Project	IEEE 802.16 Broadband Wireless Access Working Group < http://ieee802.org/16 >	
Title	Sleep Mode Operations for distributed scheduling in MR Network	
Date Submitted	2007-03-05	
Source(s)	Qu Hongyun, Sean Cai, Mary Chion, Liu Yang, Chen Yuqin ZTE Corporation 712/2, Liantang Pengji Industrial Park, Luohu District, Shenzhen, P.R.China 518004	Voice:+86-755-26773000 exd. 6614 Fax:+86-755-26773000 exd. E-mail: qu.hongyun@zte.com.cn , scai@zteusa.com
Re:	IEEE 802.16j-07/007r2:“Call for Technical comments and contributions regarding IEEE Project P802.16j”	
Abstract	This document presents sleep mode operations for IEEE 802.16j. The existing IEEE 802.16e messages are reused and new parameters are introduced in order to facilitate the sleep mode management in IEEE 802.16j.	
Purpose	Propose the sleep mode operations for IEEE 802.16j	
Notice	This document has been prepared to assist IEEE 802.16. It is offered as a basis for discussion and is not binding on the contributing individual(s) or organization(s). The material in this document is subject to change in form and content after further study. The contributor(s) reserve(s) the right to add, amend or withdraw material contained herein.

Figure 20l – Acknowledgement Header

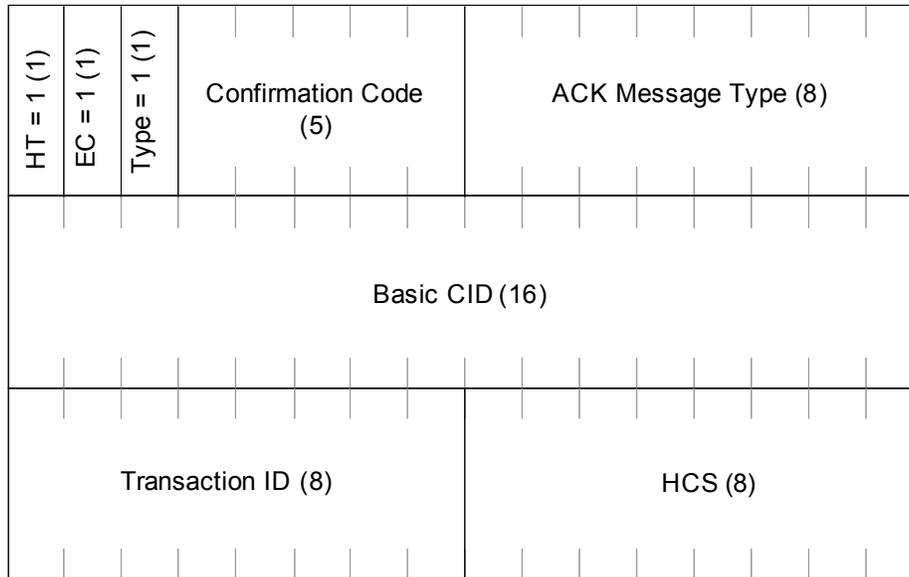
An Acknowledgement Header is sent by an RS as a response to a MAC management messages received from the MR-BS or its superordinate RS that requires acknowledgement. The RS sends this header to the MR-BS or its superordinate RS as an indication of the message reception. The Acknowledgement Header shall be sent on RS's basic CID. The Acknowledgement Header is illustrated in Figure 20l.

The Acknowledgement header shall have the following properties:

- a. This is a MAC signaling header type II. The length of the header shall always be 6 bytes.
- b. The Type field of this header shall be set to 1.
- c. The content of the header is listed in table 7k.

Figure xxx – The procedure of sleep mode

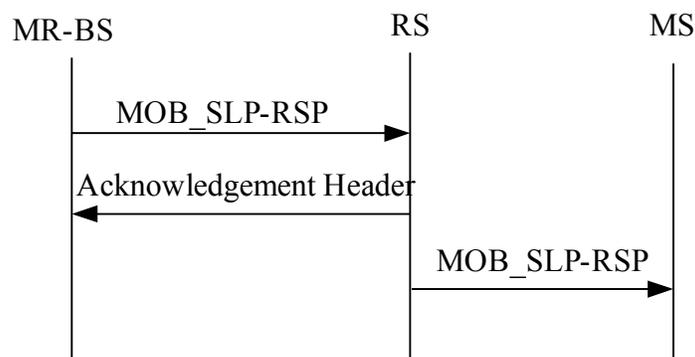
For an MS attached to the MR-BS through an RS with distributed scheduling, MS sleep mode operates as defined in section 6.3.21. All MOB_SLP-REQ messages generated by MSs attached to an RS shall be relayed to the MR-BS. The MR-BS shall be responsible for generating MOB_SLP-RSP messages, which will be relayed by RS, either in response to a MOB_SLP-REQ or unsolicited. Upon receiving MOB_SLP-RSP, the RS shall process and store the information contained in the message and send an Acknowledgement Header with ACK message Type set to 51 to MR-BS to indicate the reception of MOB_SLP-RSP. The RS shall also relay MOB_SLP-RSP to the MS(s). The MR-BS shall start timer T49 after transmitting a MOB_SLP-RSP to the RS. If T49 timer expires before an Acknowledgement header is received, the MR-BS may retransmit an MOB_SLP-RSP message to the RS. If duplicate MOB_SLP-RSP message is received at the RS, the RS shall send an Acknowledgement Header to MR-BS without further relaying the message.

For multihop relay, after receiving the MOB_SLP-RSP, the RS shall send an Acknowledgement Header to its superordinate RS to indicate the reception of message. The superordinate RS shall retransmit an MOB_SLP-RSP message if it does not receive an Acknowledgement Header before T49 Timer expires. If duplicate MOB_SLP-RSP message is received at the RS, the RS shall send an Acknowledgement Header to its superordinate RS without further relaying to the message

Figure xxx illustrates the procedure of MR-BS during MS sleep mode.
